Modification 01

Questions and Answers

Request for Proposals No. 2022- 71

Procurement of Turnkey Data Center Solution
Procurement, Installation and Training

Ministry of Education Datacenter Architecture Design

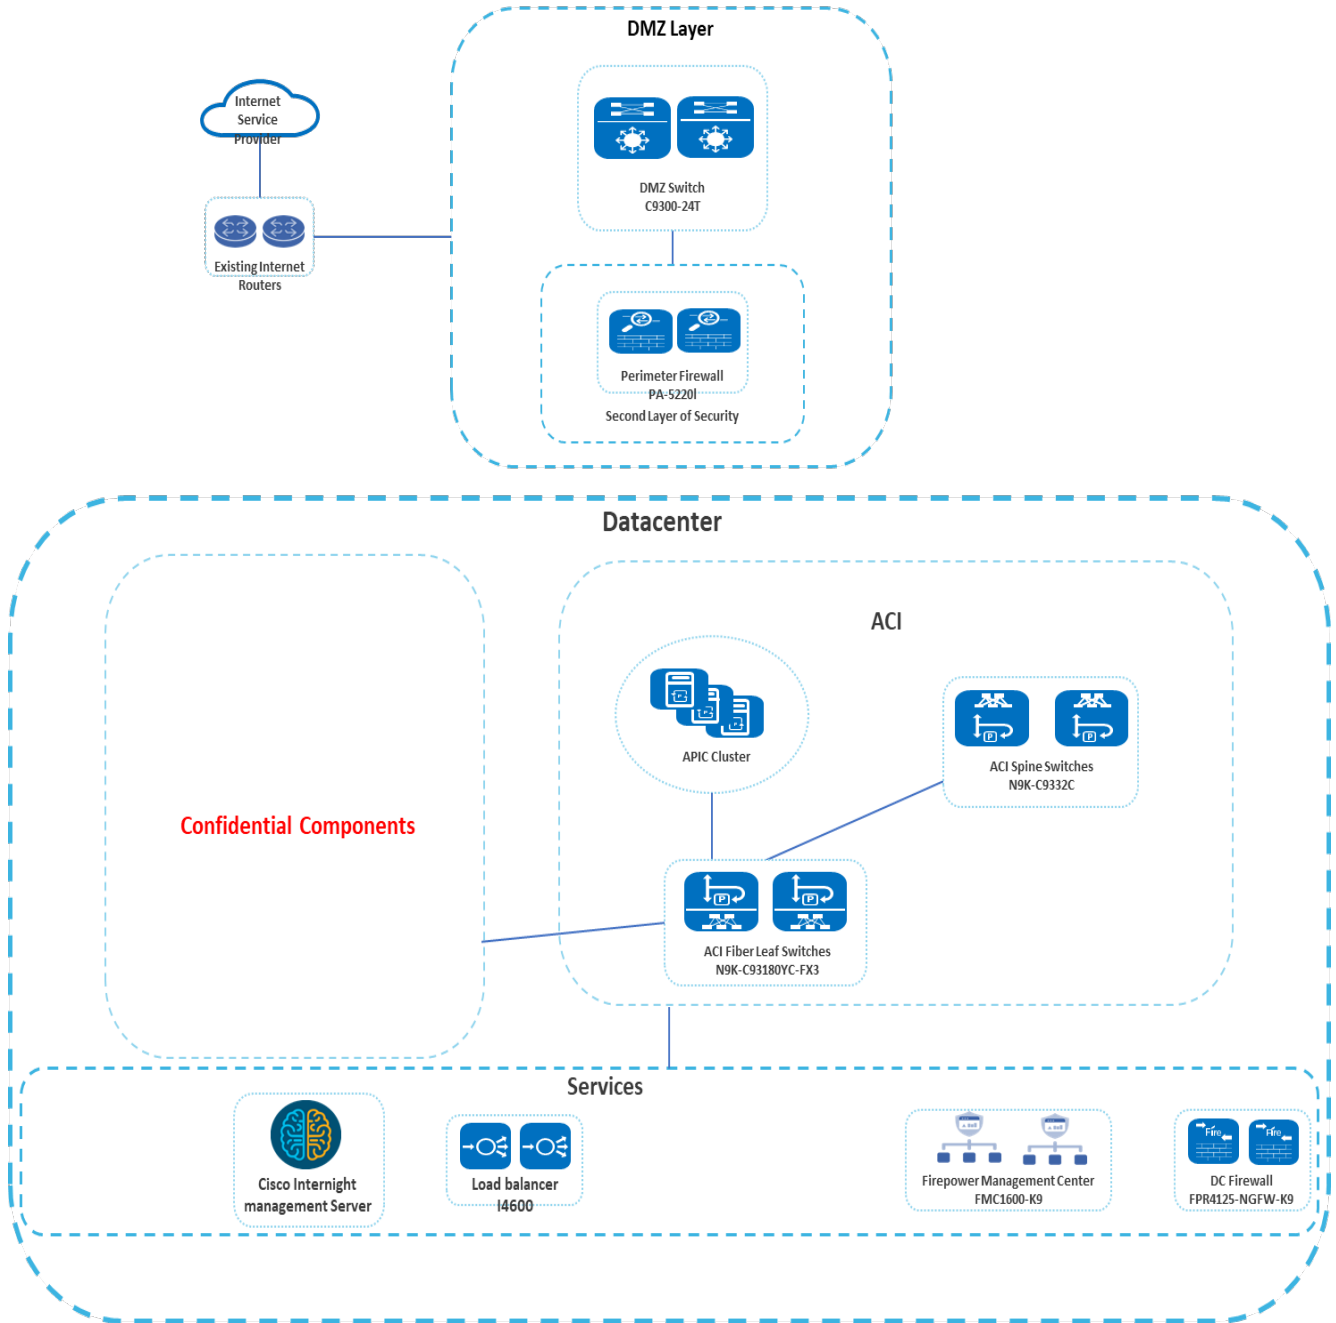
Question 16: Can you provide the architecture of the existing DC solution including the interconnections between the network & security elements?

EDC Response: *Please refer to Annex A to this modification.*
